# Access Compliance Report

## Public Rights-of-Way

| Intersection ID: 42778                  | Main Street: CLEOPATRA_DR | Cross Street: SILVERSWORD_DR            | Location:              | N                    |
| ADA ID: 99E197AED3D4                    | Ramp Type: BlendTrans1    | Initial Pass/Fail: Fail                 | Overall Compliance: No | Severity Score: 8.75 |

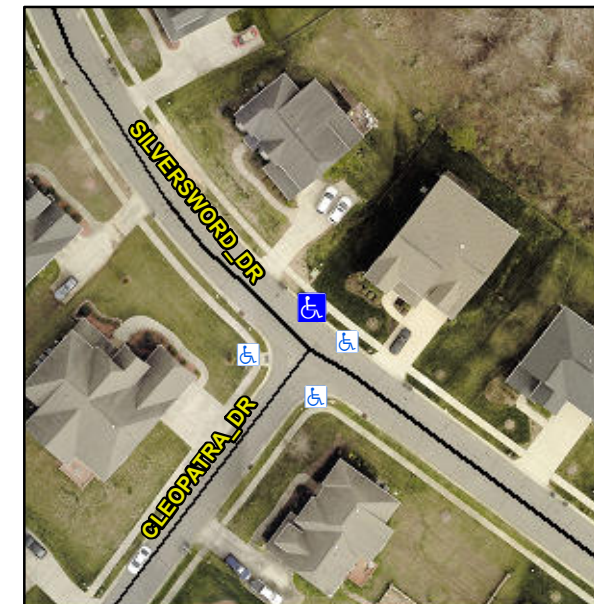
**Remove & Replace Curb Ramp With Two New Directional Ramps or Equivalent.**

**Not Found, R304.5.1**
